Submission to the Narrabri Gas Project EIS

This is a submission to the Narrabri Gas Project. Application No. SSD 6456

The Wilderness Society
Submission to the Environmental Impact Statement for the
Santos Narrabri Gas Project

Figure 1: Bushfire Risk map in Narrabri Gas Project area, indicates 72% of the project area is classed by the Rural Fire Service as Vegetation Category 1: the Highest Risk of bushfire (Courtesy: RFS and The Wilderness Society).

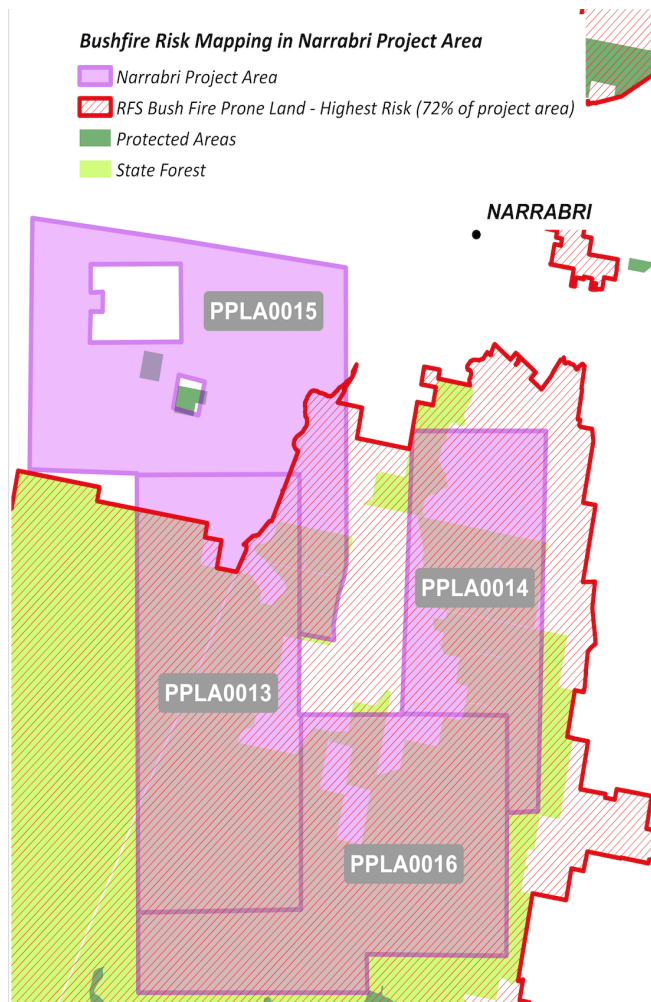
Clearing associated with the development, increased vehicle movements, increased road access and increased weed infiltration all add to bushfire risk. The CSG development will dramatically increase ignition sources as well as extracting, transporting and storing a highly flammable gas (methane) in the project area. Santos does not appear to have a clear bushfire strategy, especially for gas flaring which cannot be shut down on catastrophic fire days.

low intensity hazard reduction burns in these forests in the Pilliga.¹⁸⁴ However, these rates can be much higher in a higher intensity fire in bushfire season. Species such as the koala, pygmy possum, barking owl and microbats would suffer. Figure 1 shows a map sourced from the Rural Fire Service indicating that 72% of the NGP area is categorised as Vegetation Category 1: the “highest risk” of bushfires. Vegetation Category 1 has the highest combustibility and likelihood of forming a fully developed fire, including heavy ember production. This vegetation is dry sclerophyll forest, high fuel loads of up to 20-30 tonnes per hectare.
